**FIELD OBSERVATION REPORT - Bids #14**

Permit No. 18-131555-00 BC  
 Owner: Vintage Grand Condo Assn, Inc.  
 Project Address: 4017 Crookers Lake Blvd., Sarasota, FL  
 Contractor: RL James Inc  
 Inspector (s): Mark Boss / Steve Mainardi  
 Type of Assessment: Progress

**PROJECT NAME:**  
 WOOD FRAME REPAIRS & RELATED WORK (PHASE II)  
 VINTAGE GRANDE CONDOMINIUM ASSOCIATION, INC.  
 4012 CROCKERS LAKE BLVD., SARASOTA, FL 34238

PHOTOGRAPH #1

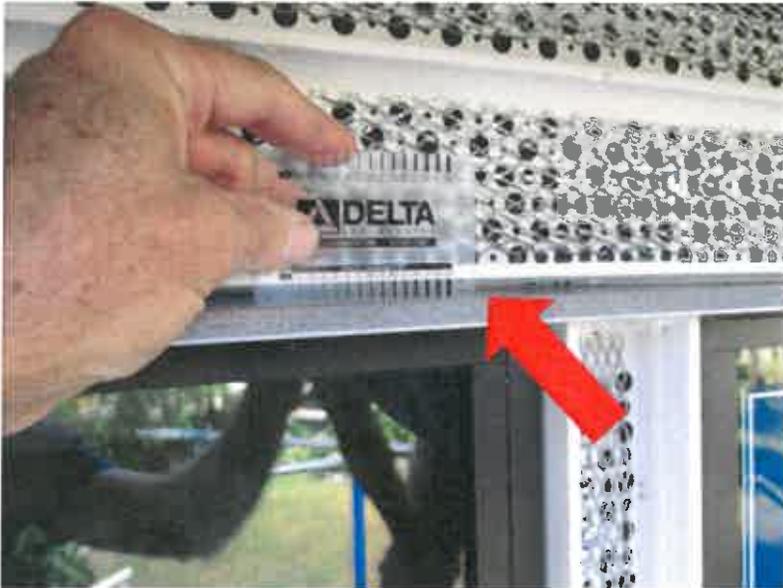
Stucco accessories and lath mock ups in review. 2" X 4" metal lath butterfly tied at each corner has been installed and approved as per specification and drawings.

**PHOTOGRAPH #10**

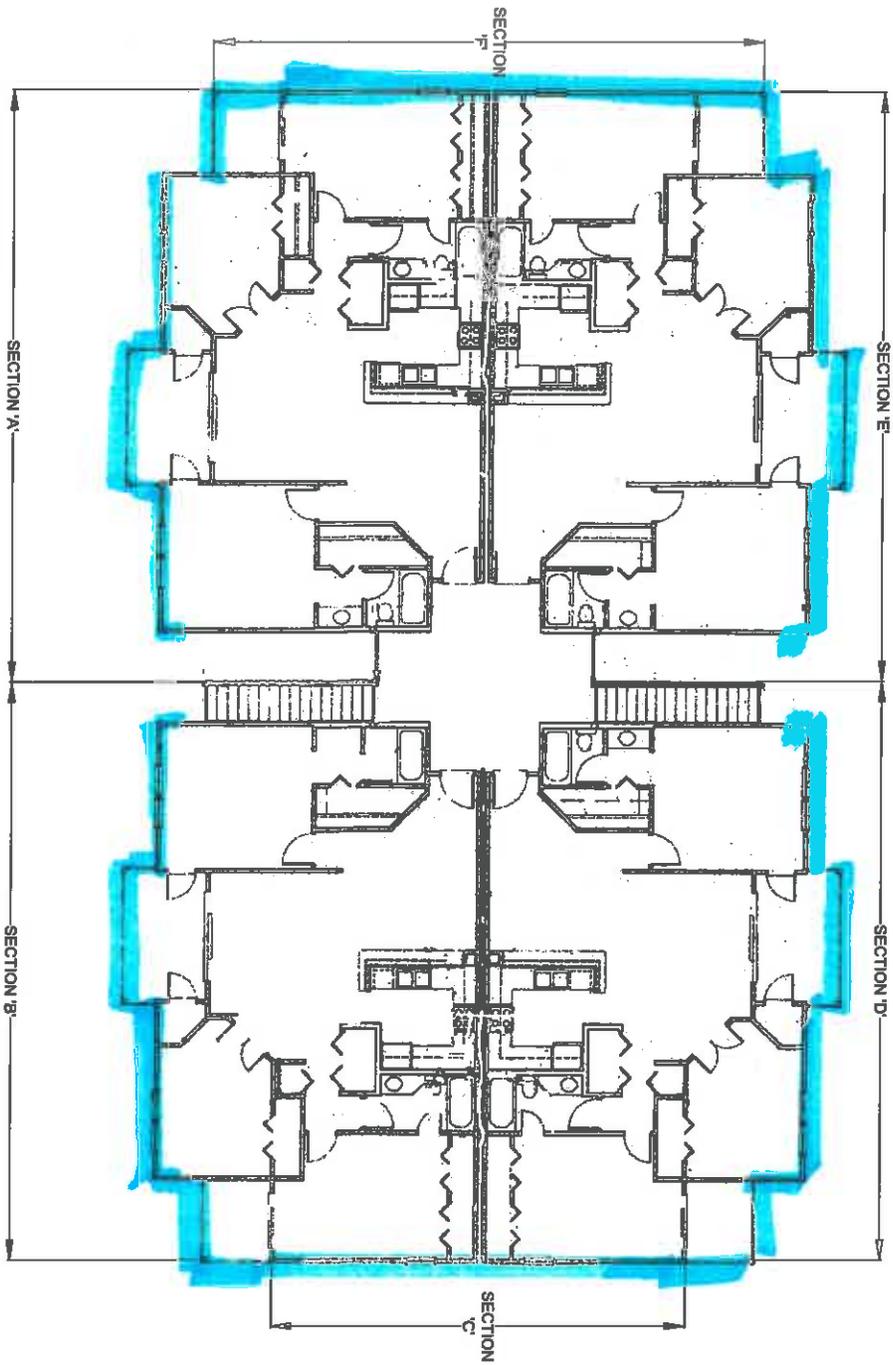
Contractor has begun replacing soffit and soffit screen as per specifications.
